CHANGE ORDER

Meadowdale Beach Park and Estuary Restoration Project

Change Order Proposal

COP No.	Date
020	4/3/2023

RD-1

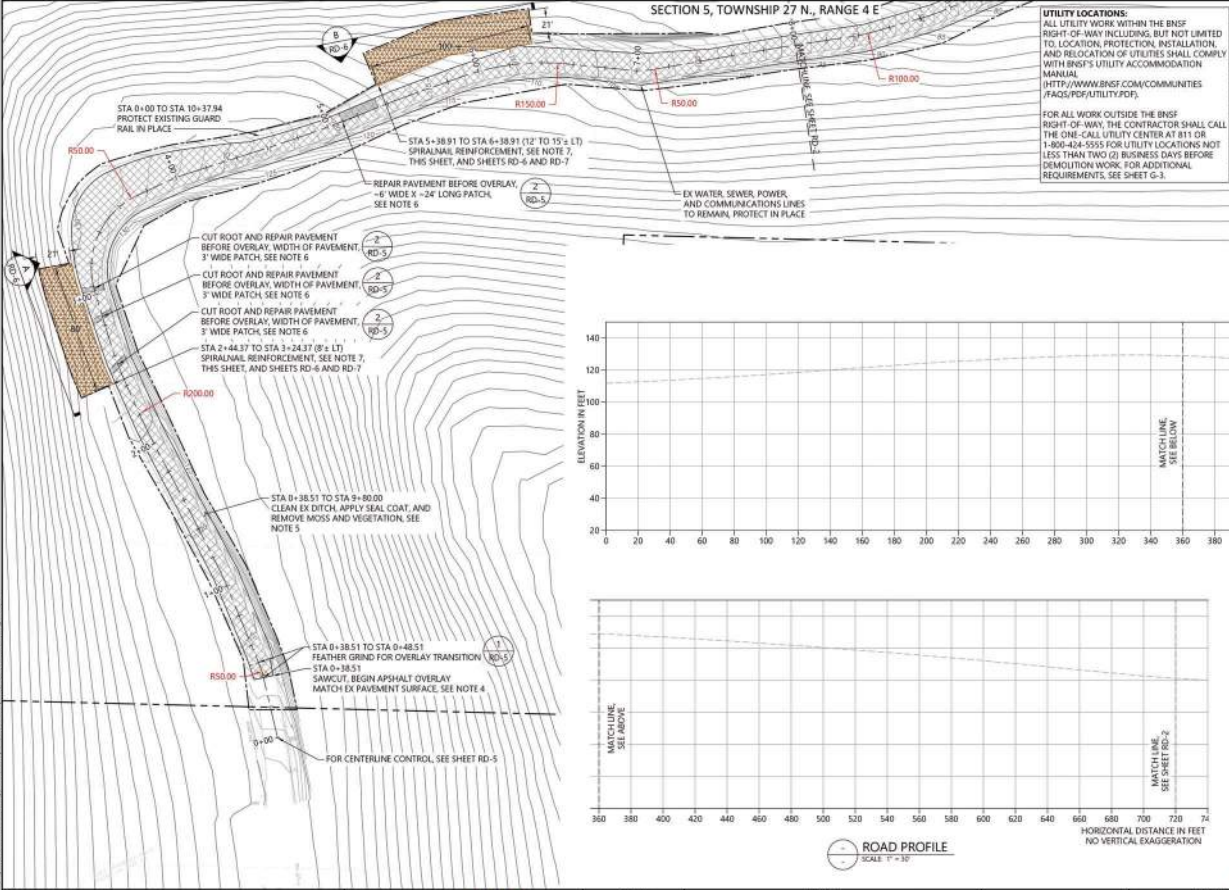
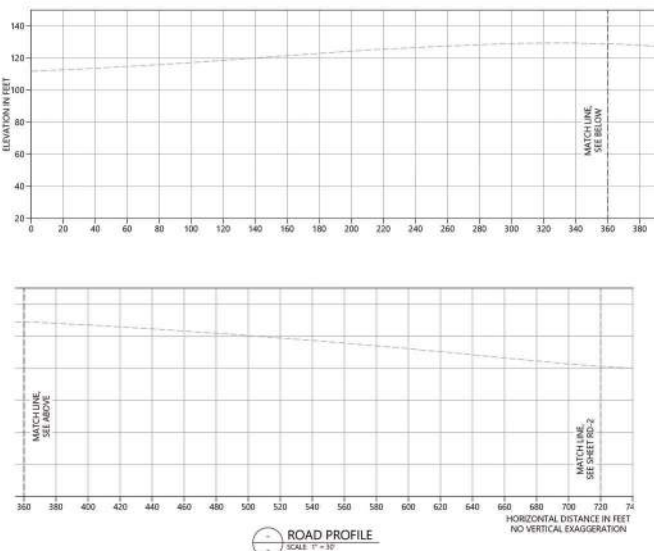
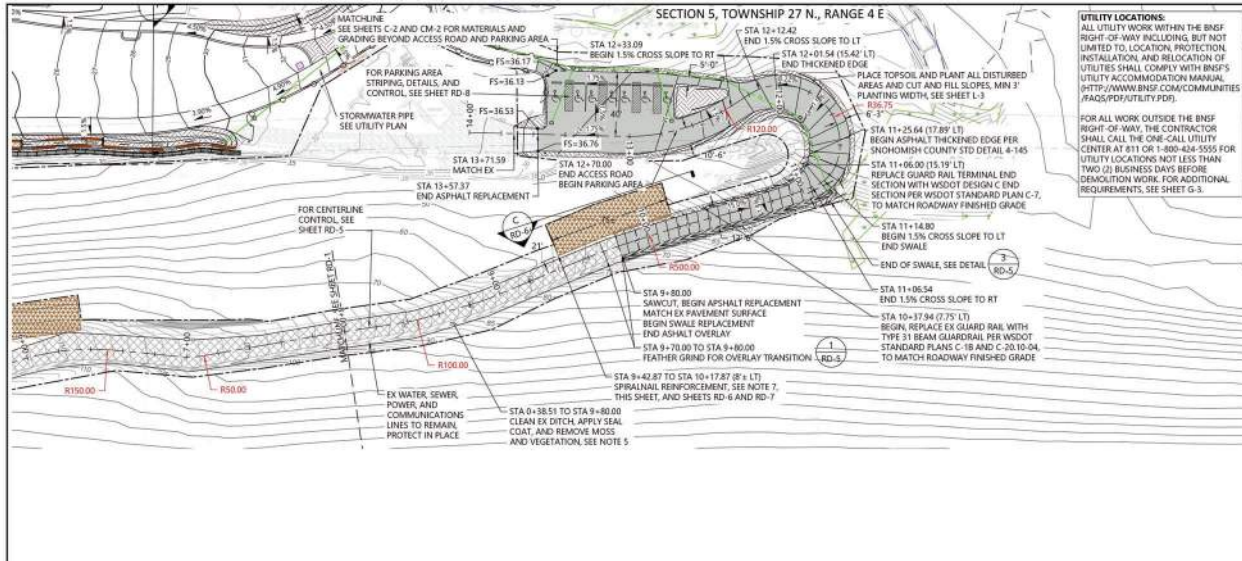
Additional Asphalt Repair Quantity Estimate						
(for Contractor Information Only)						
<p>Scope: Drawings RD-1 and RD-2 show overlay and pavement repair from Sta. 0+38.1 (near the mechanical gate) to Sta. 9+80 (beginning of new roadway construction). During a recent site review, the current road condition has deteriorated since the initial design has been developed and additional pavement repair work is needed.</p> <p>This estimate presents the additional work, above the original design, to make the pavement repairs indicated on the attached redlined drawings RD-1 and RD-2.</p>
